Working Party on Inland Water Transport

Working Party on the Standardization of Technical and Safety Requirements in Inland Navigation

Recommendations on Harmonized Europe-Wide Technical Requirements for Inland Navigation Vessels (Resolution No. 61, revised)

Amendments to section 2–7.3 “Data for the identification of a vessel”, chapters 4 “Safety clearance, freeboard and draught marks”, 15a “Specific requirements for passenger sailing vessels” and 22a “Specific requirements applicable to craft longer than 110 m”, and new section 3–6 “Other provisions”

Figure 4-3.7
Measurement/draught scale

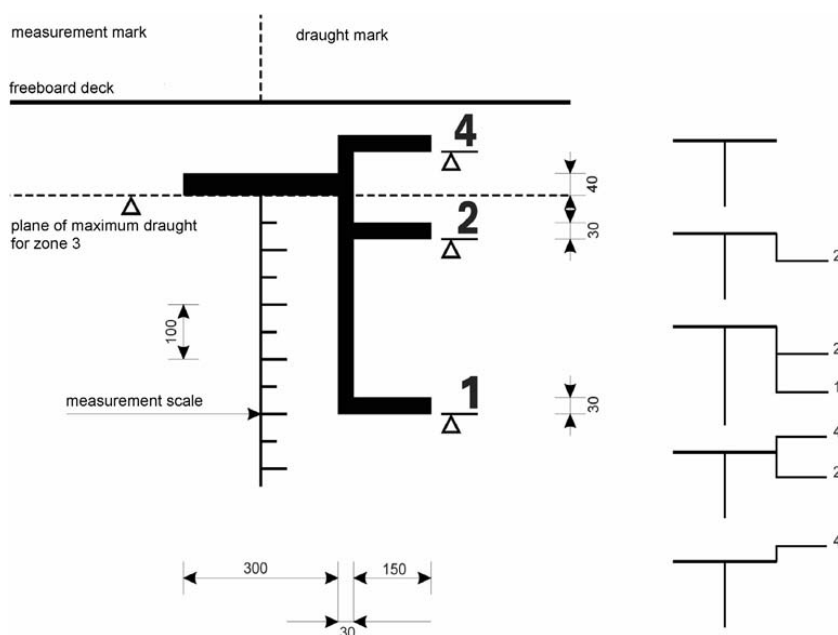
4-3.7 ~~Article 4.04(7)~~. For vessels operating on zones of inland waterways other than zone 3 (zones 1, 2 or 4²) the bow and stern pairs of draught marks provided for in paragraph **4-3.3** shall be supplemented by adding a vertical line to which one or, in the case of several zones, several additional draught lines 150 mm long shall be affixed towards the bow, in relation to the draught mark for zone 3.

This vertical line and the horizontal line shall be 30 mm thick. In addition to the draught mark towards the bow of the vessel, the relevant zone numbers shall be indicated in lettering 60 mm high × 40 mm deep (see Figure 4-3.7).

The lower edge of each draught line shall correspond to the plane of maximum authorised draught for the navigation zone concerned.

Fig. 4-3.8
Freeboard mark

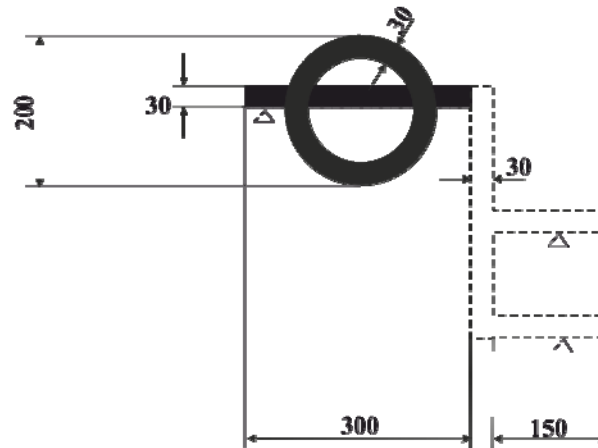
4-3.8 ~~4.4.1.2~~ **The centrally located measurement/draught scale for zone 1 and 2 may be replaced by a freeboard mark.** ~~The freeboard mark for vessels for zone 3 consists of a horizontal band of 300 mm long and 40 mm width. The freeboard mark for zones 1 and 2 shall consist of a ring intersected through its centre by a horizontal line which shall be supplemented if necessary by additional freeboard lines.~~

The width of the ring and of all the other lines of the freeboard mark shall be 30 mm; the outer diameter of the ring shall be 200 mm; the length of the horizontal line intersecting the ring shall be 300 mm; and the size of the numerals designating the zones shall be 60 x 40 mm (Figure 4-3.8).

The centre of the ring shall be placed amidships. The lower edge of the horizontal line which intersects the ring shall pass through the centre of the ring and shall constitute the freeboard line.

If the vessel is intended to navigate in several navigation zones, a vertical line and additional freeboard lines 150 mm in length shall be applied forward of the centre of the ring.

The lower edge of each freeboard line shall correspond to the freeboard prescribed for the navigation zone concerned.

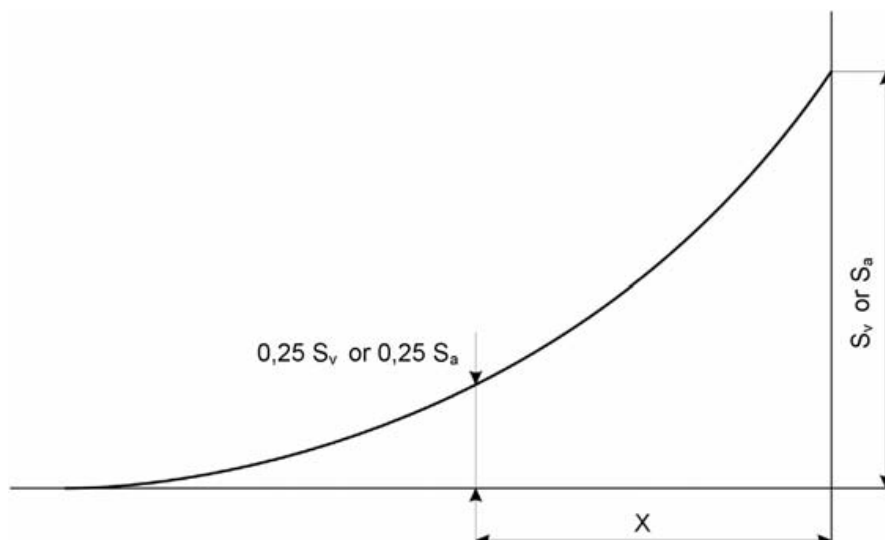
4-4.2.5 ~~Article 4.02(5)~~ The effective aft/forward sheers Se_v/Se_a are calculated using the following formulae:

S_v is the actual forward shear, in mm; however S_v shall not be taken to be more than 1 000 mm;

S_a is the actual aft shear, in mm; however S_a may not be taken to be more than 500 mm;

$$p = 4 \cdot \frac{x}{L}$$

x is the abscissa, measured from the extremity of the point where the shear is $0,25 S_v$ or $0,25 S_a$ (see figure).
